FCC ID: IQX98C1770

Re: About the modification of 17" COLOR MONITOR

I, hereby, declare that all modification on the E.U.T.,
FCC ID: IQX98C1770, will be added or layout on the mass production
products. Modifications are shown as below:

FCC ID: IQX38C1770
Front side of general appearance

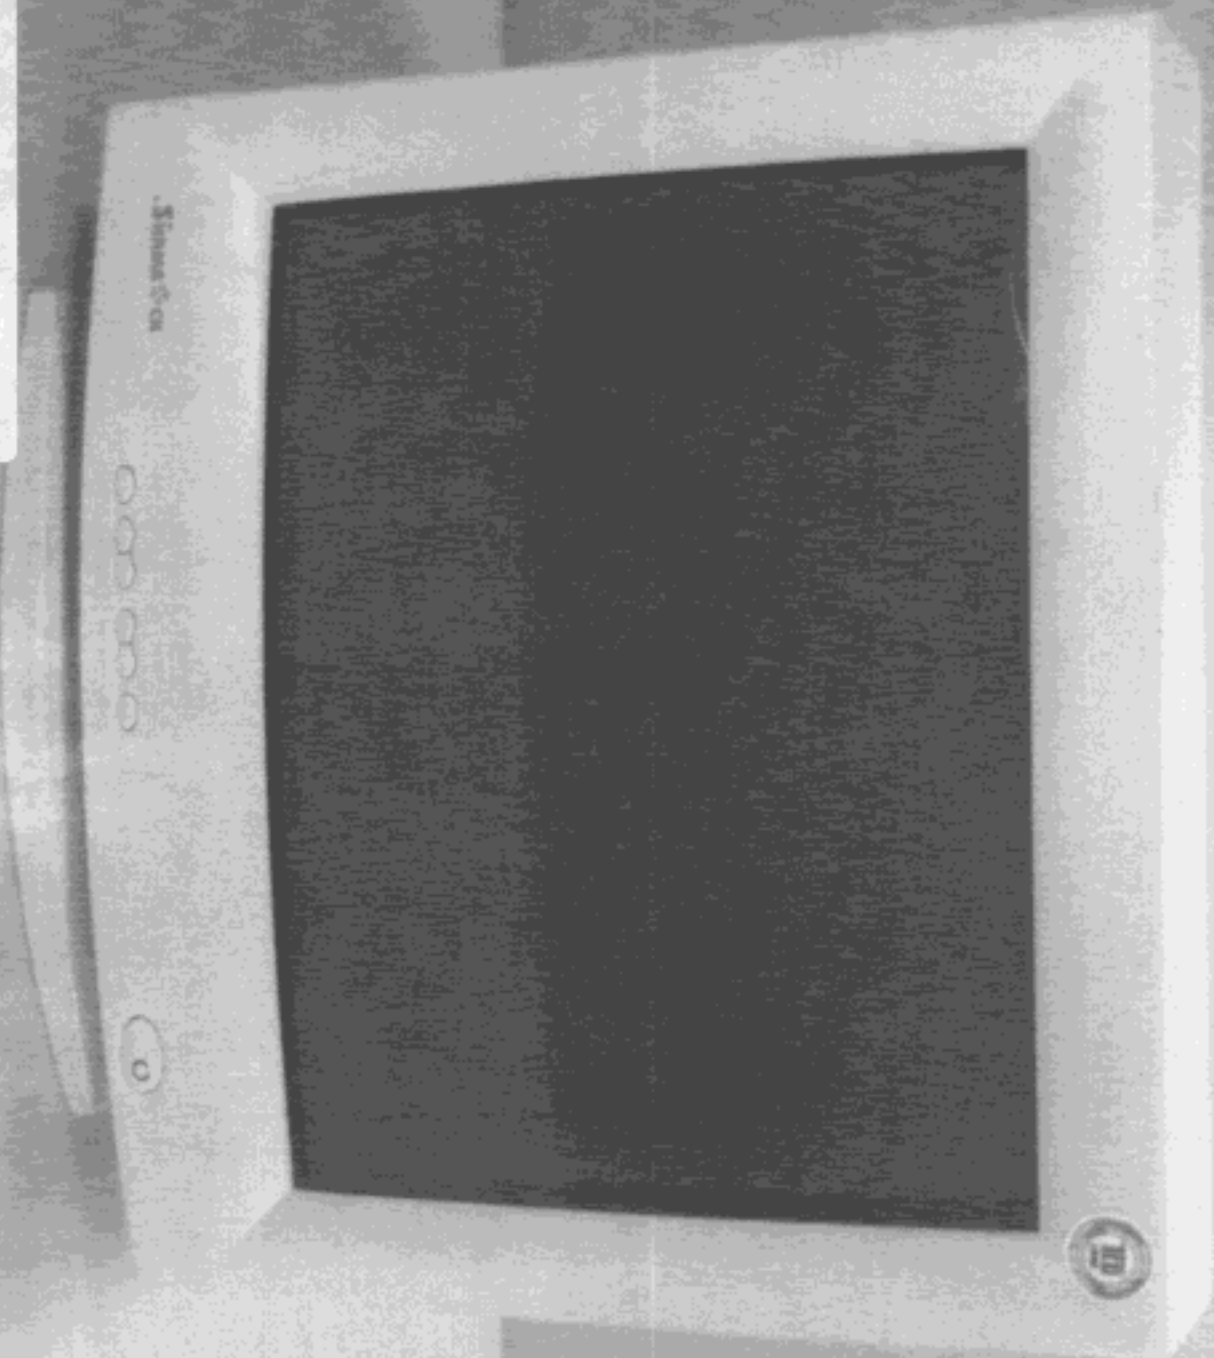
1. Add ferrite core on video cable .
(As the photo No. 2)
2. Add metal shield on CRT board .
(As the photo No. 5)
3. Add ferrite core on video cable. *braid*
(As the photo No. 5)
4. Add ground wire x 3ea from CRT board wire to main board & CRT board metal shield.
(As the photo No. 6)
5. Add ground wire x 2ea from *CRT* Braid wire to main board.
(As the photo No. 7)
6. Add jumper wire on CRT board from Q307 Heatsink to CRT socket GND.
(As the photo No. 11)
7. Add jumper wire on main board from U202 PIN 1 to C726.
(As the photo No. 13)
8. Add jumper wire on main board from C132 to C12P.
(As the photo No. 13)
